Planning Commission MEETING AGENDA

Thursday, October 17, 2024 - 1:00 PM
Council Chambers, Easton Town Office
14 S Harrison Street

- b. **Application Number:** 2024 - 1261
Applicant: Rauch Inc.

Location:	410 Needwood Avenue (Silo Square) Tax Map 0105, Grid 00EA, Parcel 2226
Zoning District:	BC
Request:	Sketch Site Plan and conceptual approval for the construction of 28 single-family attached dwellings with associated stormwater management facilities and other site improvements including the demolition of the existing silos, storage buildings and a gravel road on the property. The Applicant is also seeking a waiver for bufferyard requirements.

SHEET NO.: G-100

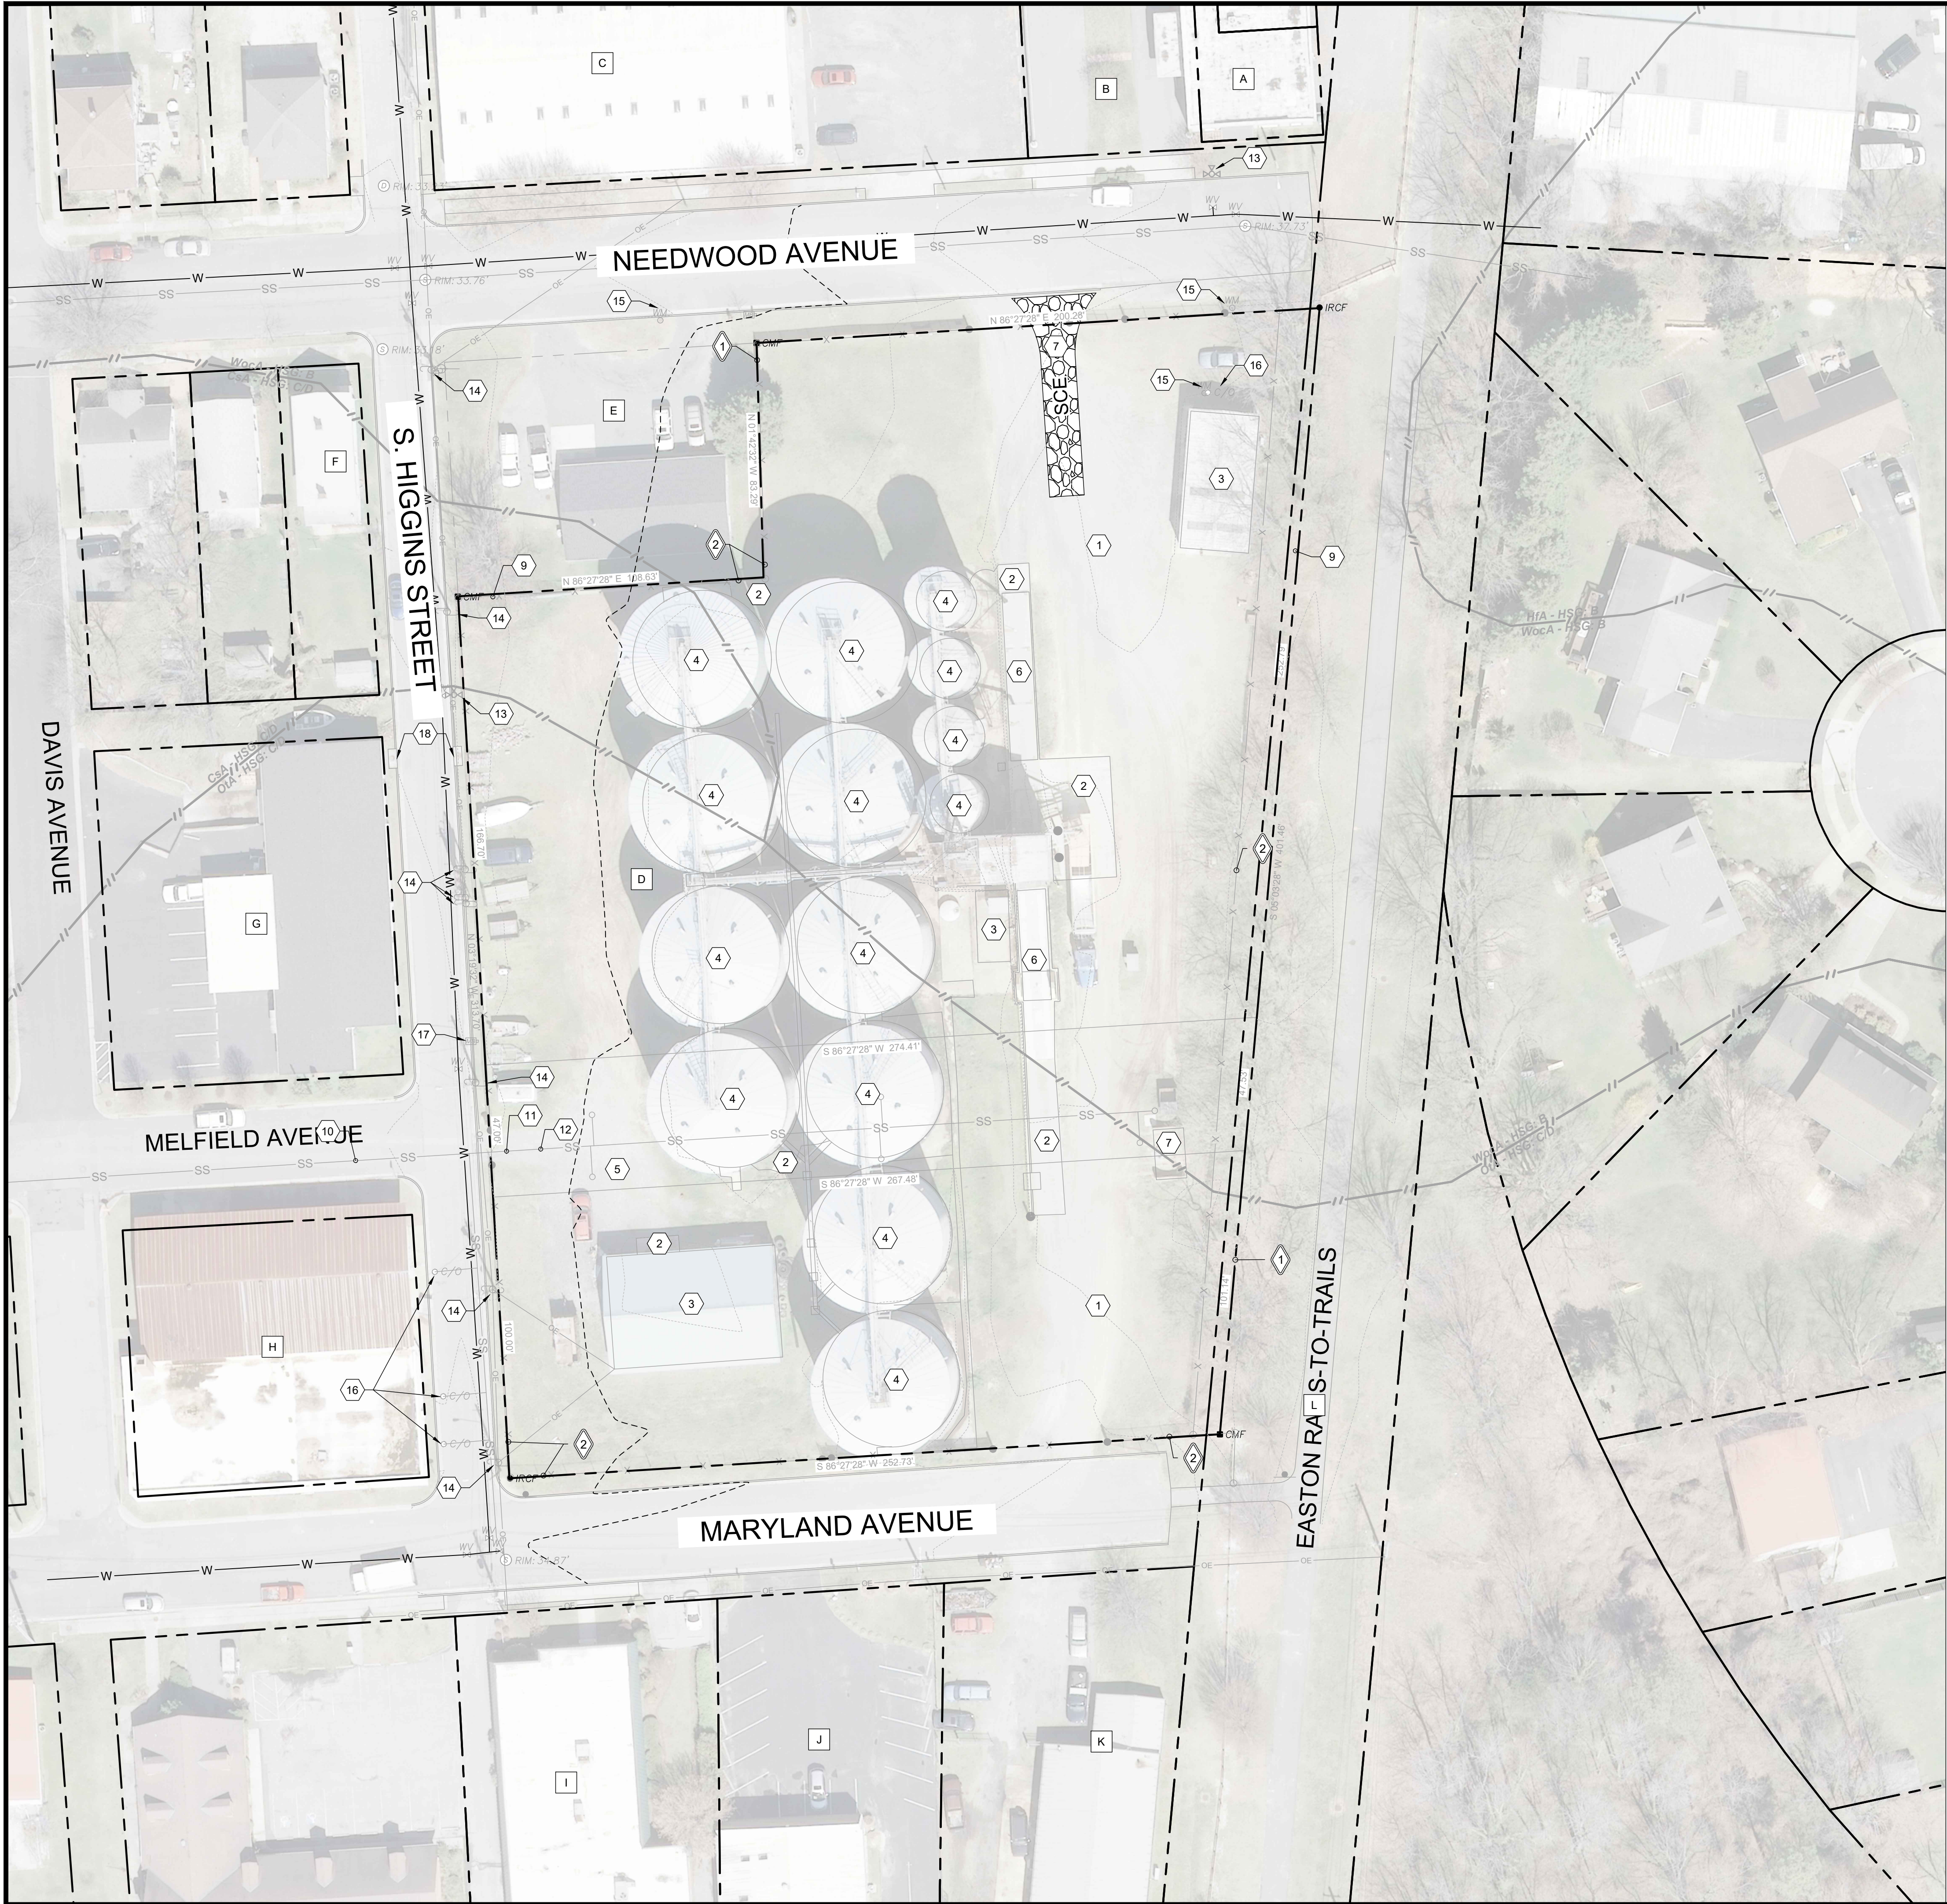
2. Revise the Site Data on sheet G-100 to include all existing Zoning Districts; Business Commercial, PRD Boundary and **PUD Infill Boundary**.
3. Per Appendix B, Sketch Plan Submittal Checklist requires the location of exterior lighting to be shown on plan view.

7. Per § Section 28-501 B(1) through (8) from the Town's Zoning Ordinance, respond to the development requirements and add statements onto sheet G-100.

12. Per § Section 31-3.2 from the Town's Forest Conservation Ordinance #718, state on sheet G-100 exemption "O", *the proposed activity is on a previously developed area covered by impervious surface and is located within the priority funding area.*
